PLANNING RESPONSES
SUNLIGHT HOUSE
APRIL 2023

EXTERNAL ALTERATIONS

INTERNAL ALTERATIONS

6. RISER ACCESS PANEL

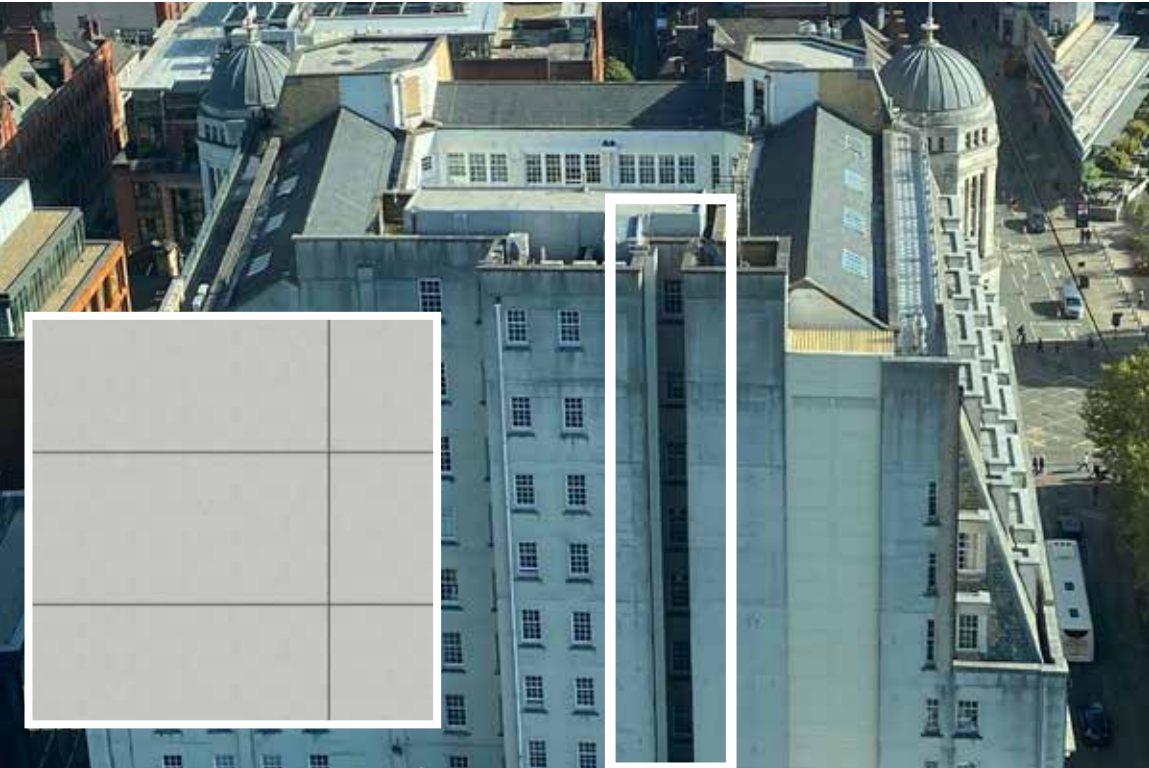
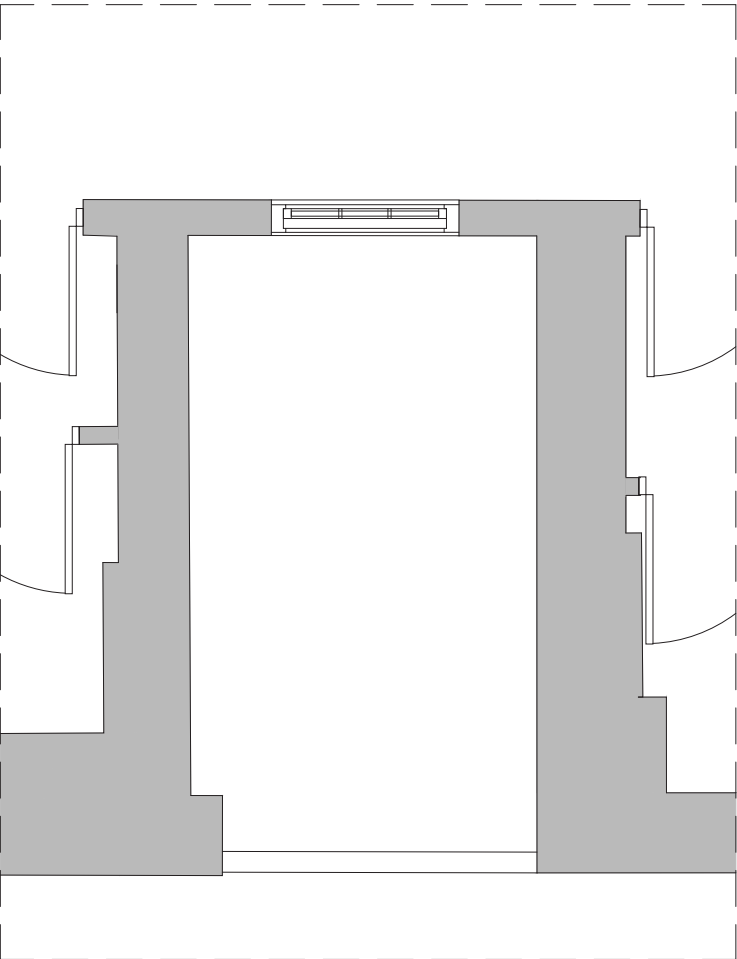
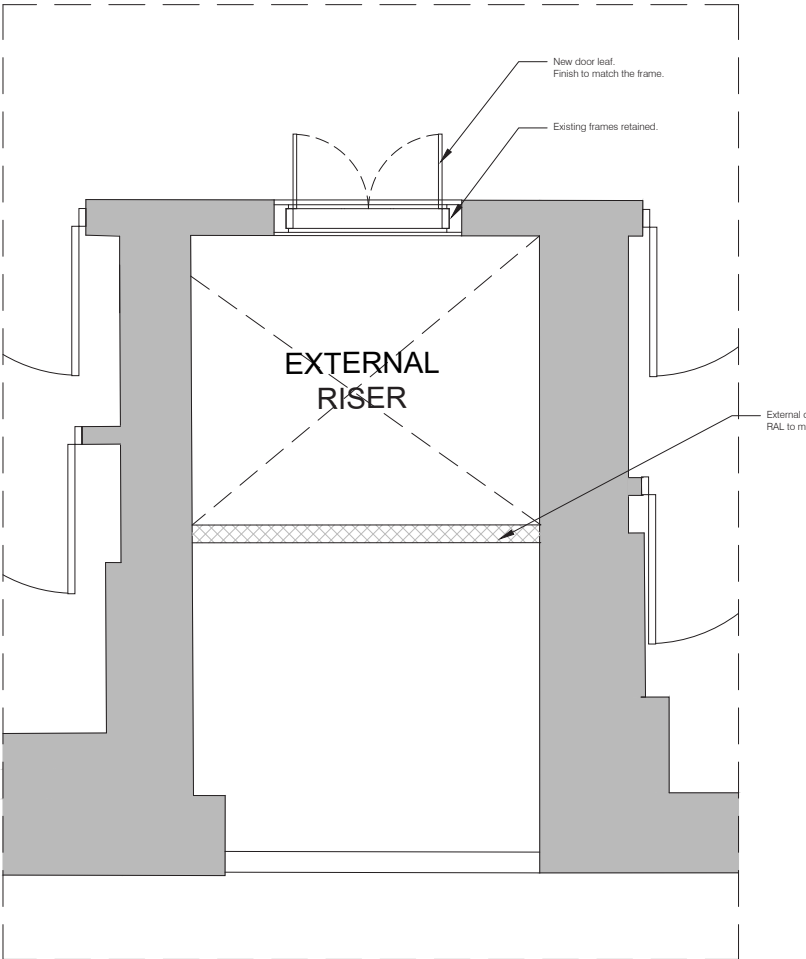
Details of the conversion of the existing windows to 'riser access panes' (drawing A-21101) and the external manifestation of the proposed service riser should be provided.

Drawing now provided to work within the frame opening. External riser finish to be a white rainscreen style system to match current rendered finish and existing ductwork casing.

7. SOLAR PANELS TO QUAY STREET

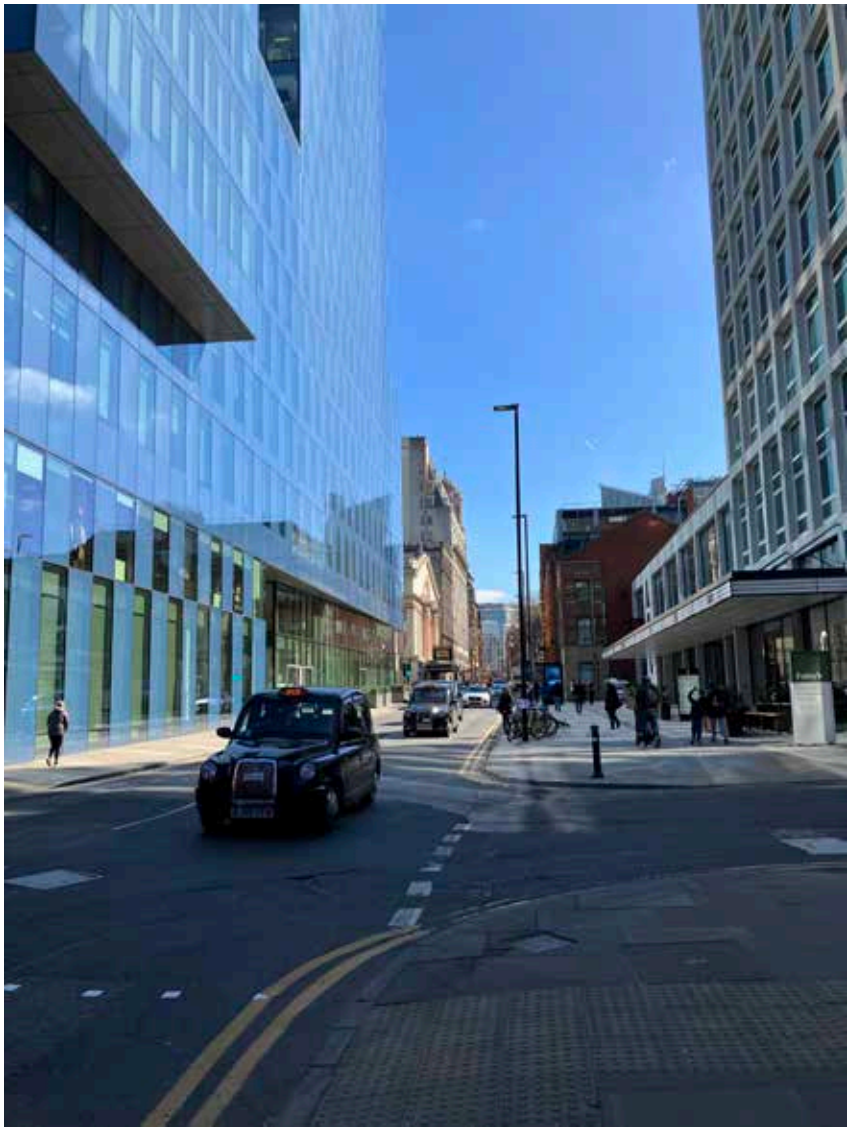
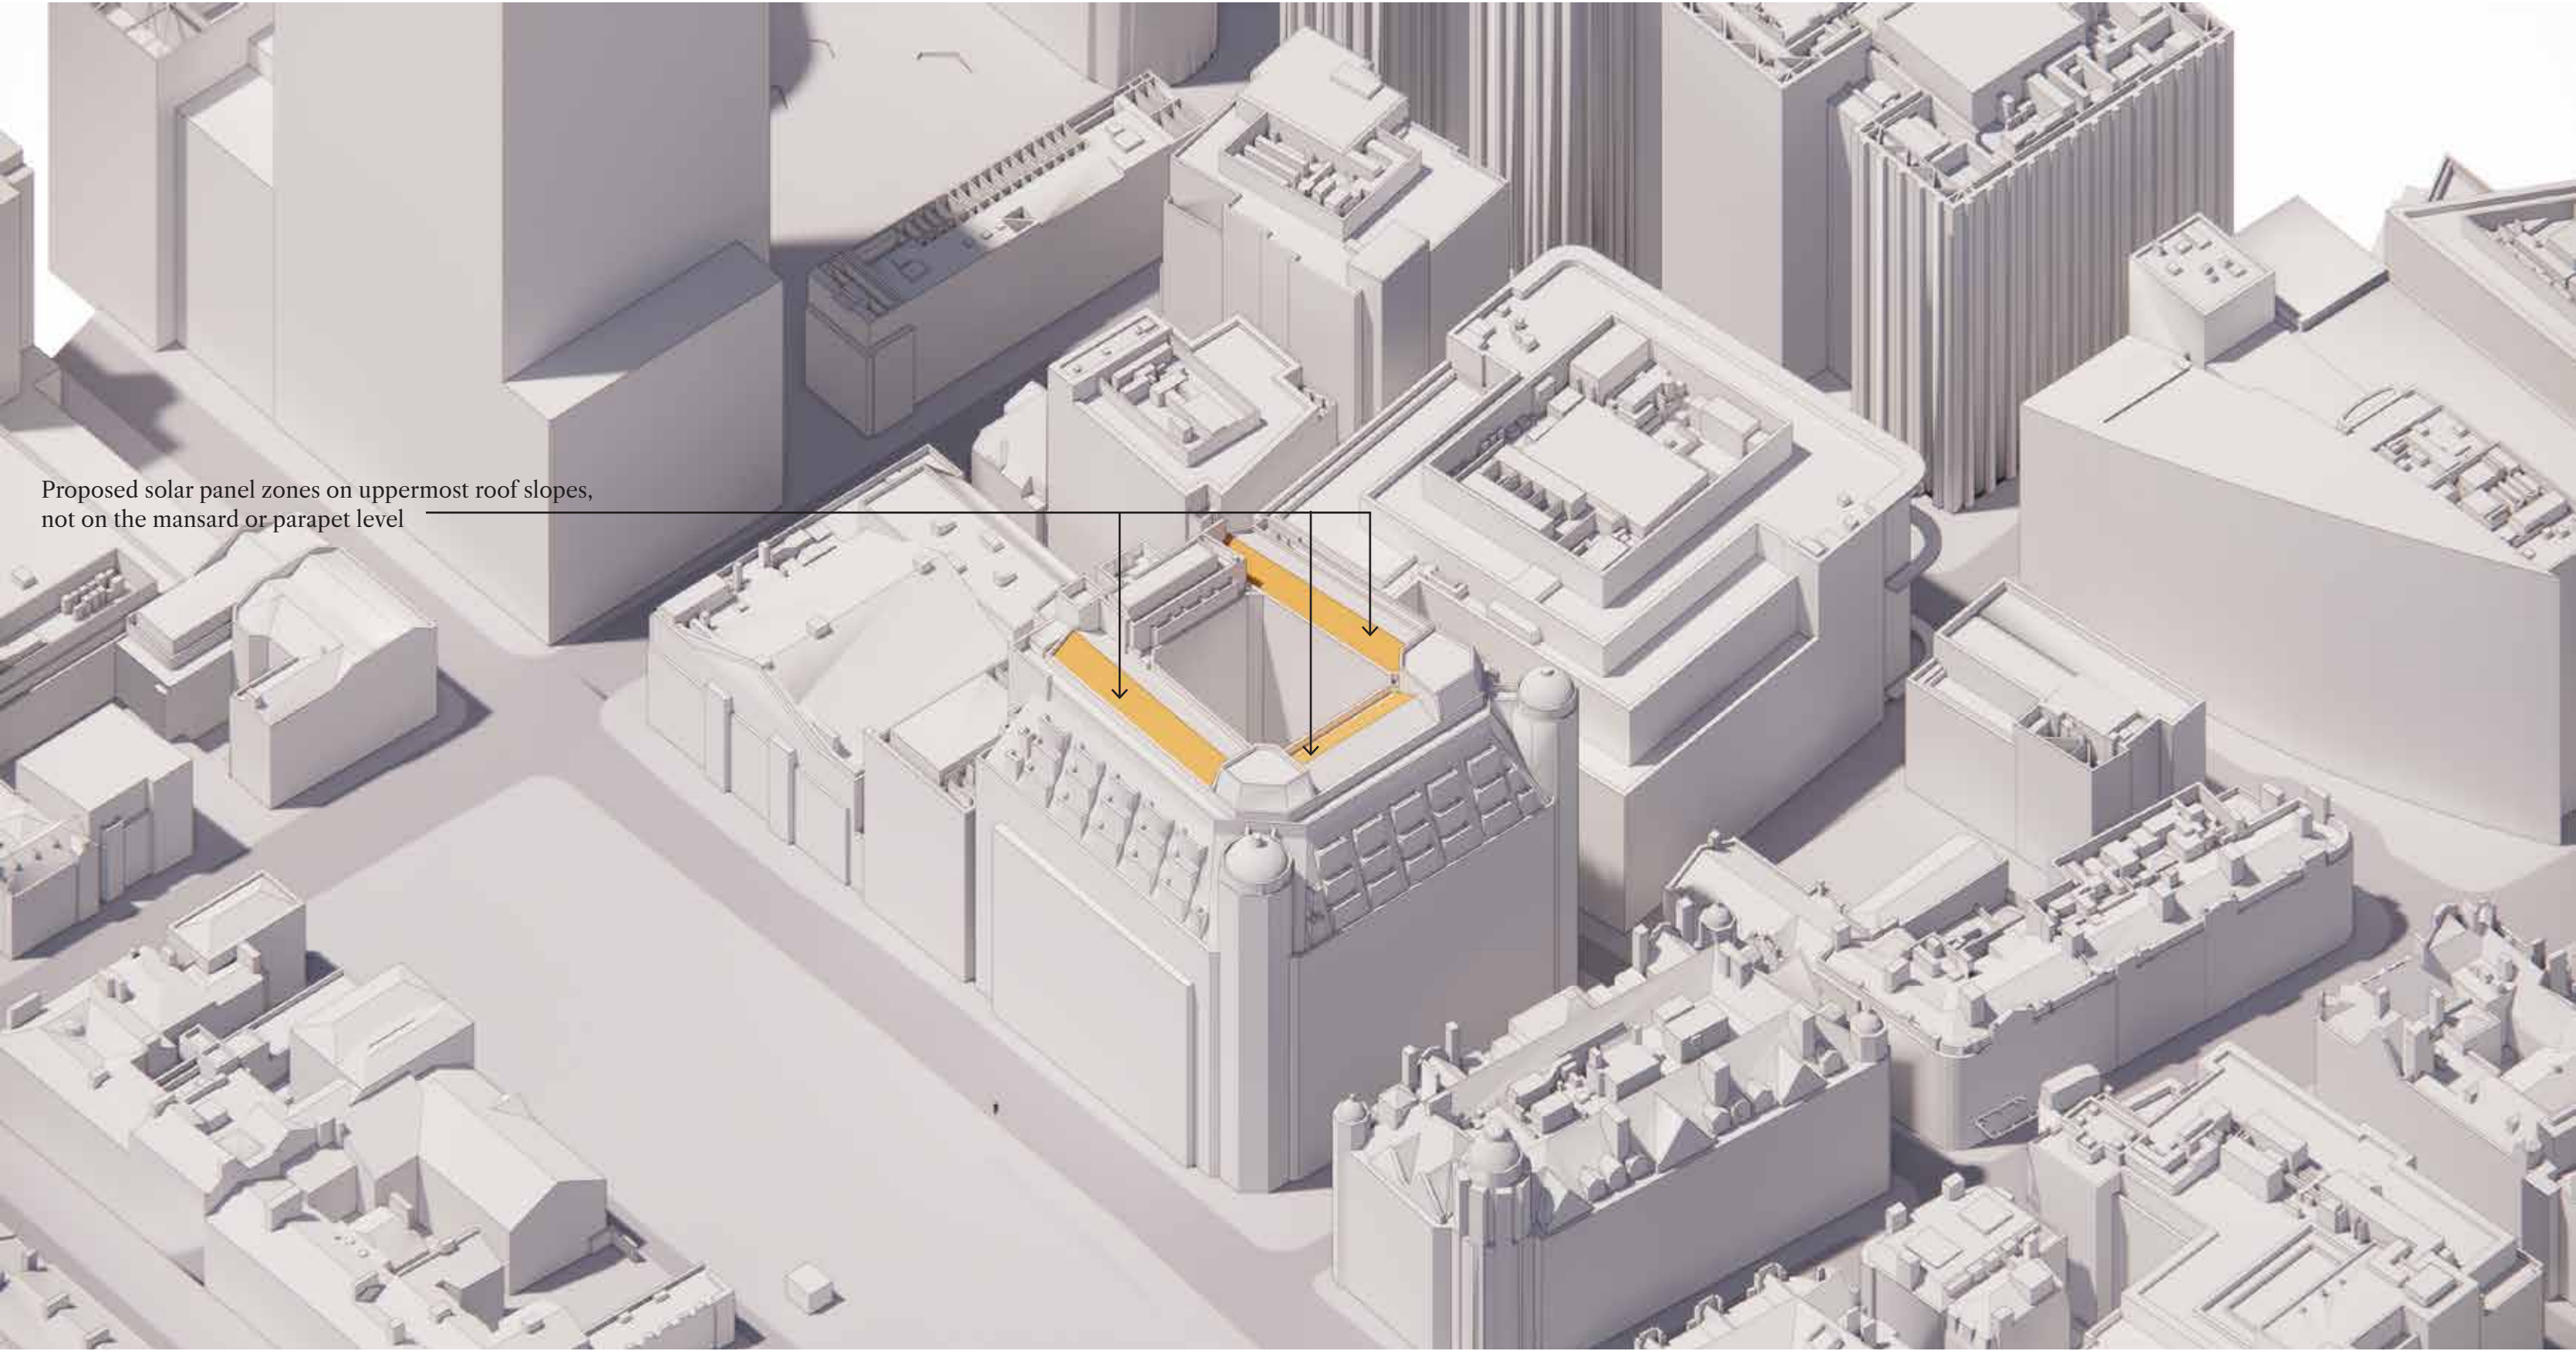
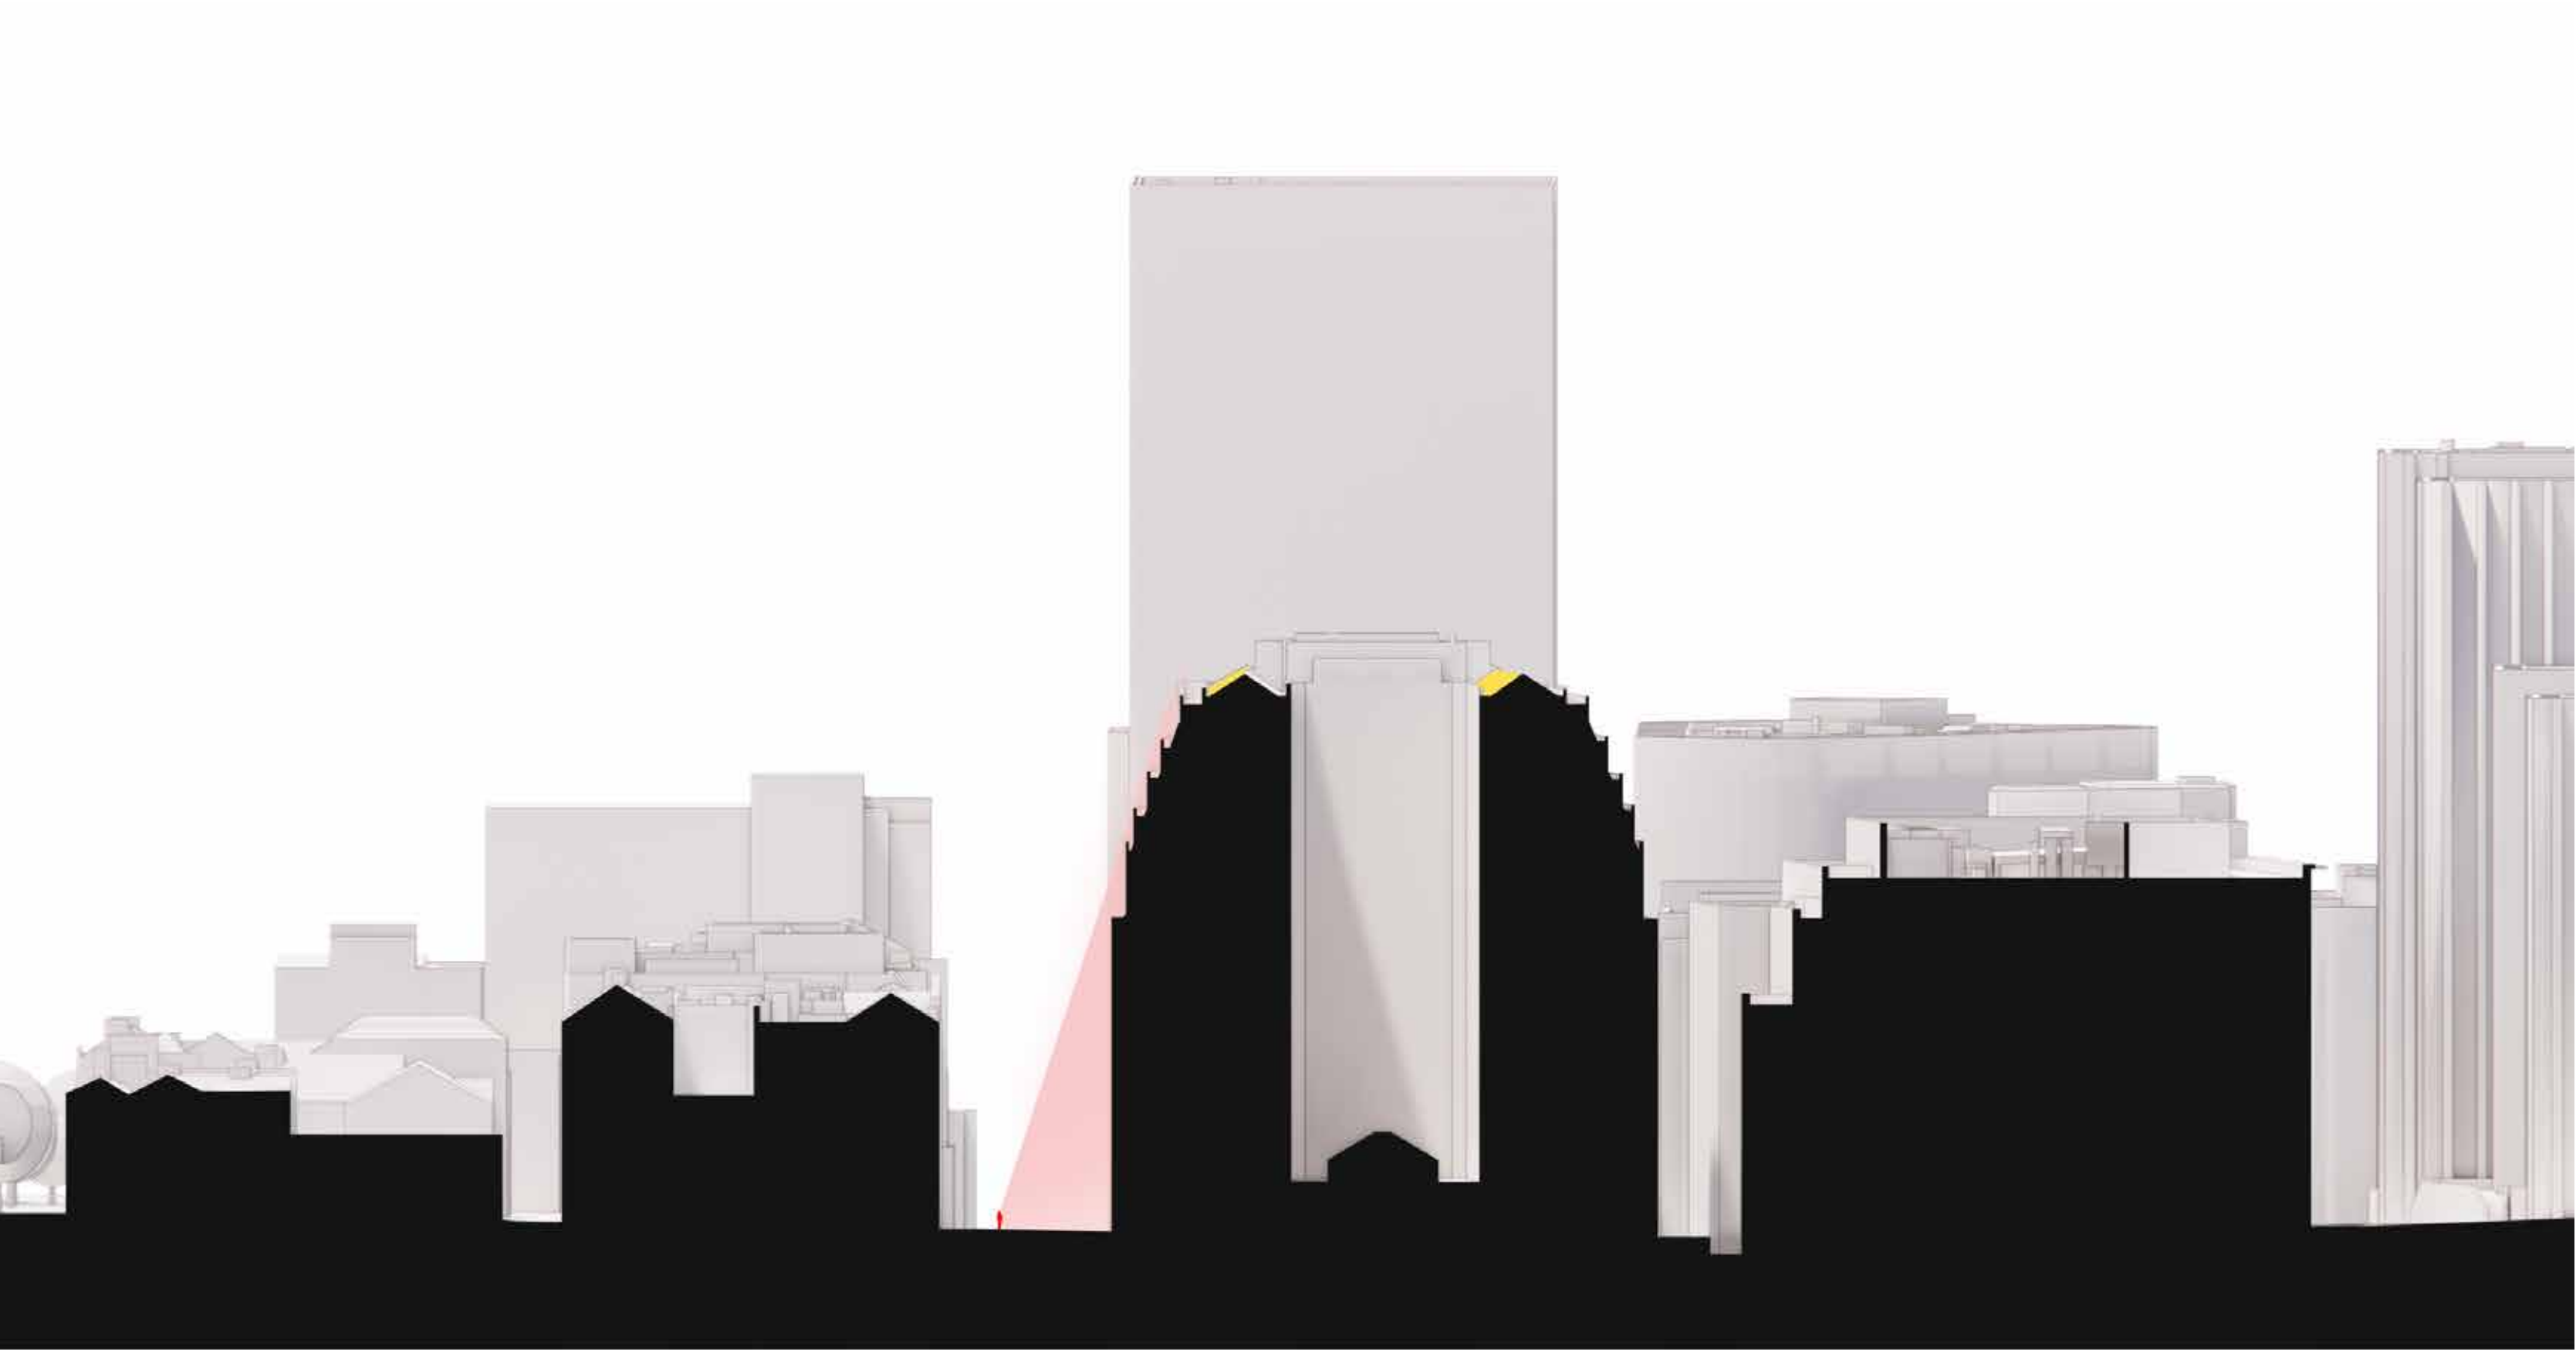
The solar panels to the Quay Street elevation should be removed. We will only support them on the internal roof slopes.

The loss to the south facing slope would be a significant reduction in output of the panels of 5kWp out of 17.94kWp resulting in a 30% reduction of output.

- due to the shape of the steep mansard levels between 9 and 12 and then the further parapet to inset roof of level 13, the slopes above the vaulted ceiling of level 13 are not visible in street views.
- the proposed tile hanger fixing has been discussed further with heritage suppliers and is the preferred solution due to the reduced impact on original material and unknown substrate/roof structure under the tiling. The projection is limited to c. 200mm from the roof plane, meaning that even with projection the panels will still not be visible from any key views.
